SEWAGE DISPOSAL SYSTEM

DEPARTMENT OF HEALTH AND MENTAL HYGIENE

SUBDIVISION Evergreen Valley LOT 14 ROAD 3138 Evergreen Way

EVERGREEN WAY
 IMPROVEMENT LOCATION SURVEY
 LOT 14
 EVERGREEN VALLEY ESTATES
 SECTION SIX
 THIRD ELECTION DISTRICT
 HOWARD COUNTY, MD.

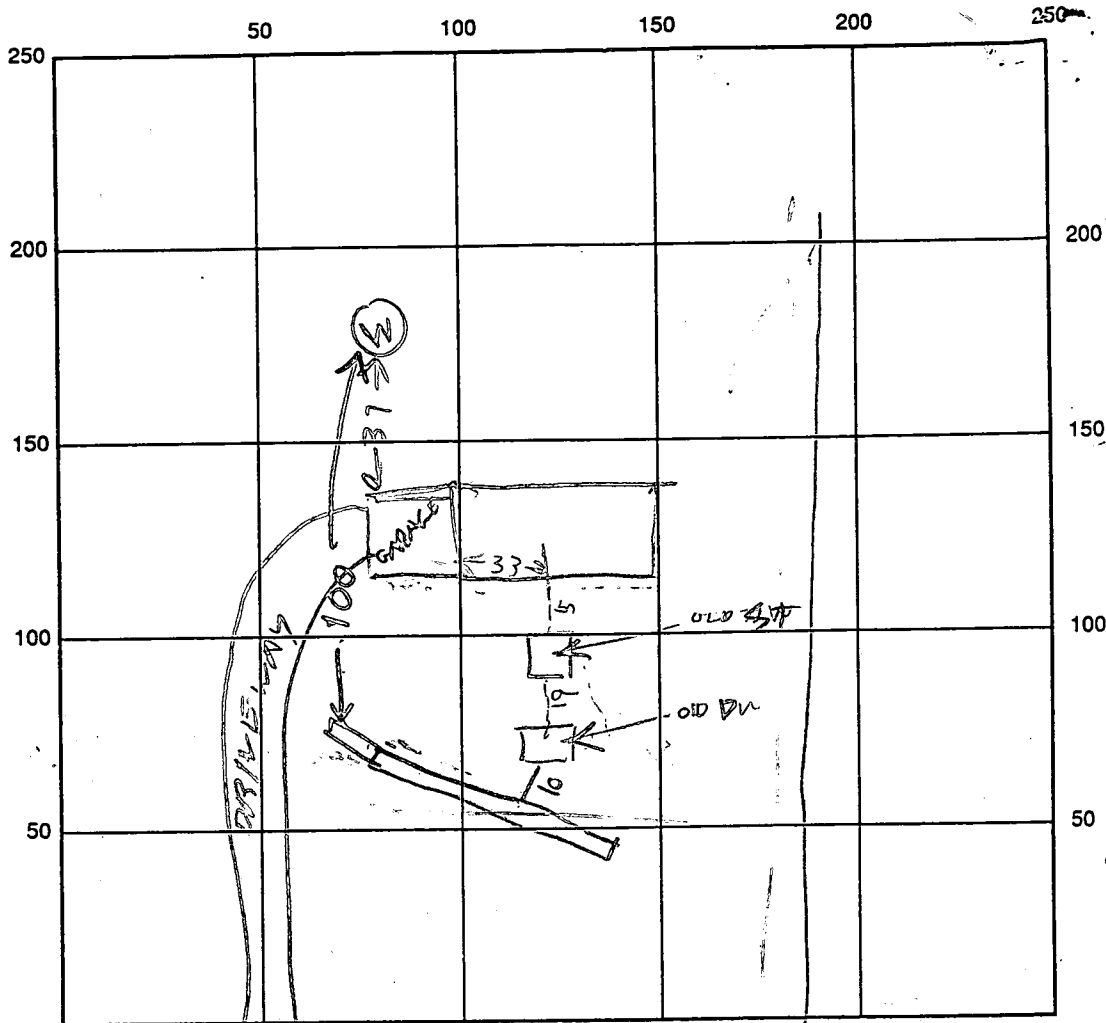
REPAIR - DRYWELL IS FULL. CALL FOR INSPECTION WHEN GROUND IS OPENED SO SANITARIAN CAN RECOMMEND REPAIR.

TRENCH OFF OLD DRY WELL INLET 2 FT BELOW
GRADE BOTTOM 9 FT BELOW GRADE 7 FT
STONE

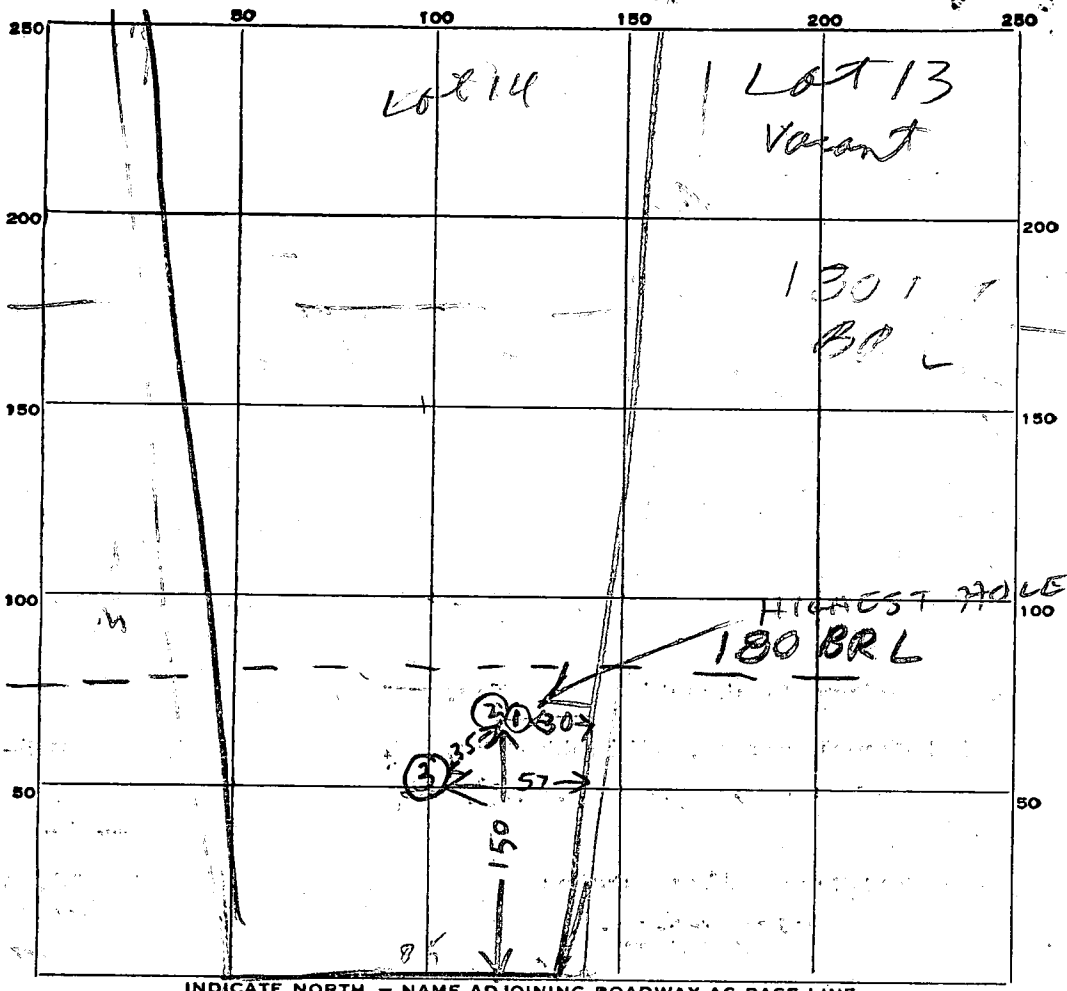
CR Lot 13 for set back & see if per m OK

REMARKS *Retest needed because BRL changed*

PLAT TO ACCOMPANY APPLICATION FOR BUILDING PERMIT FOR HUDSON CONSTRUCTION CO. 8957 CHAPEL AVENUE ELLICOTT CITY, MARYLAND

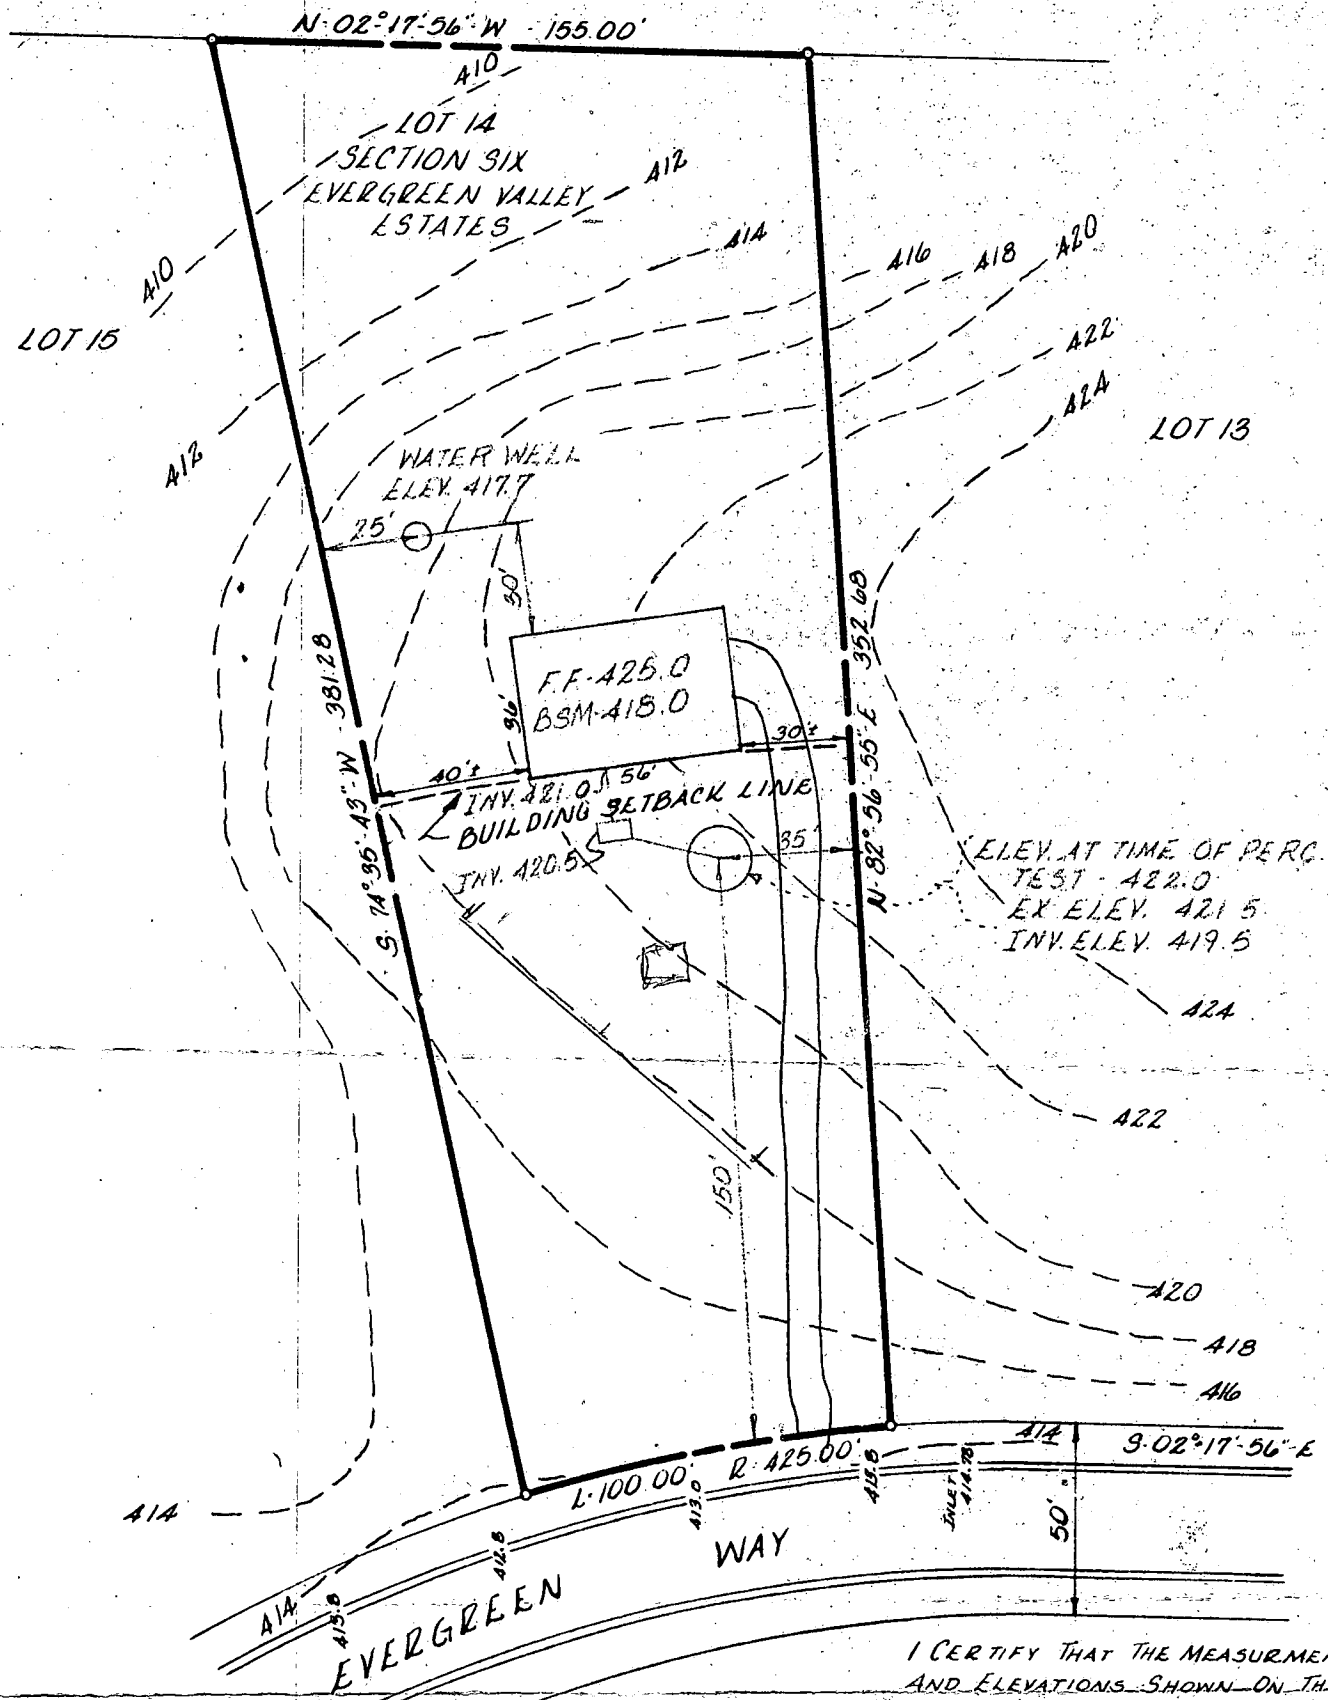
Revised Plans O/K 3/20/72 R. Hodges

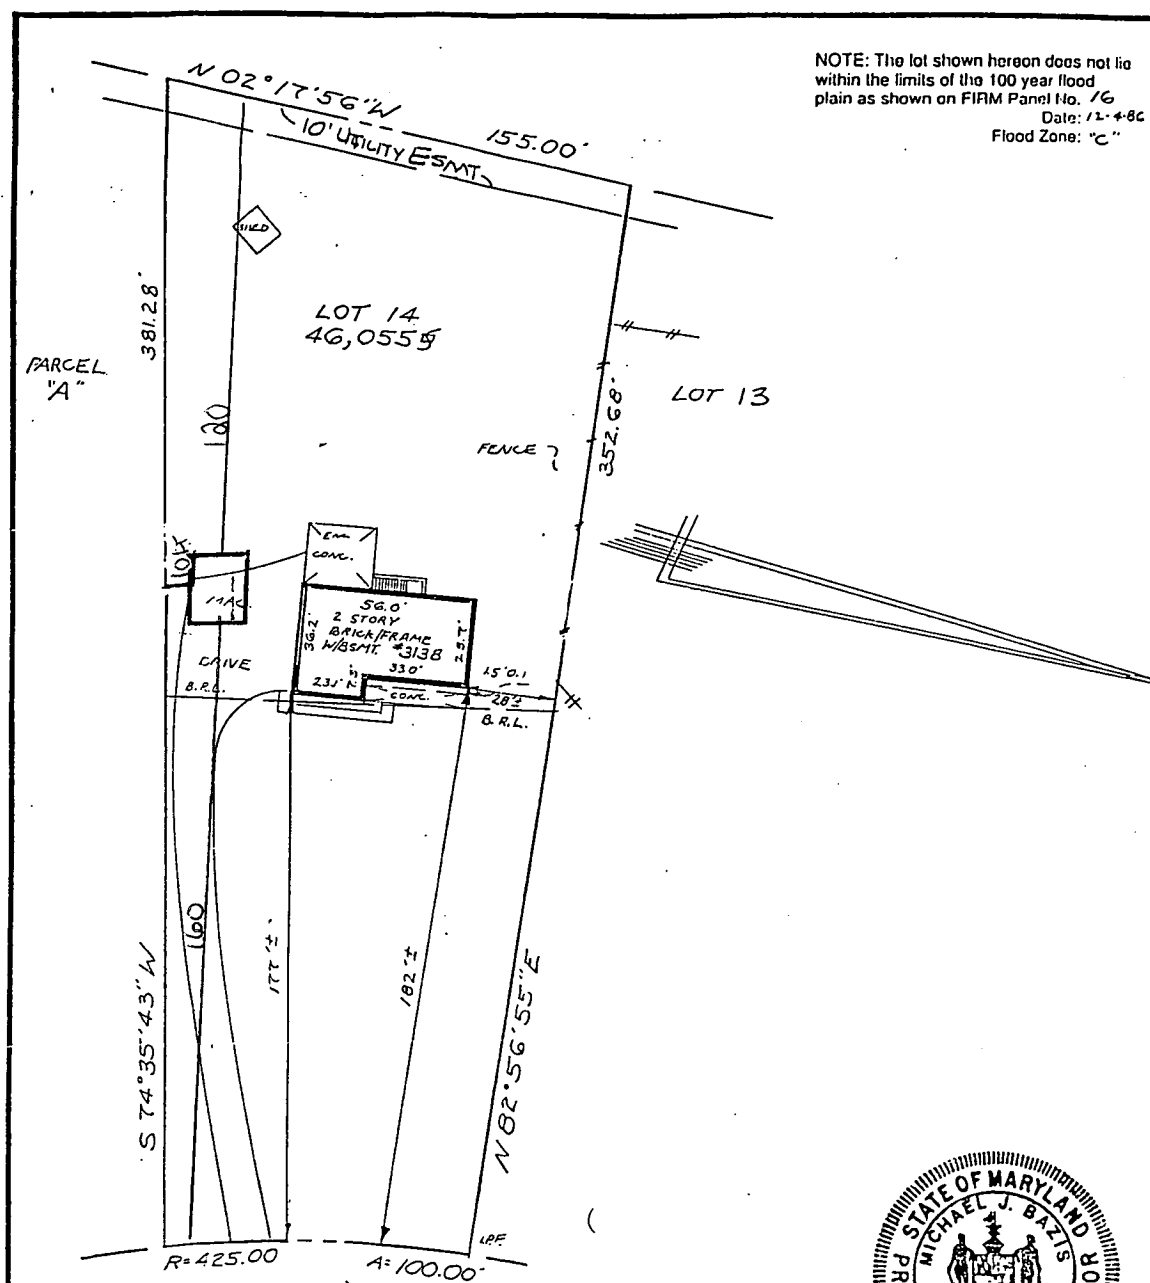
Comments: Relocation of pool

Revise Plan To
 Show relocation of
 Pool 30' from side
 property line,
 25' from well
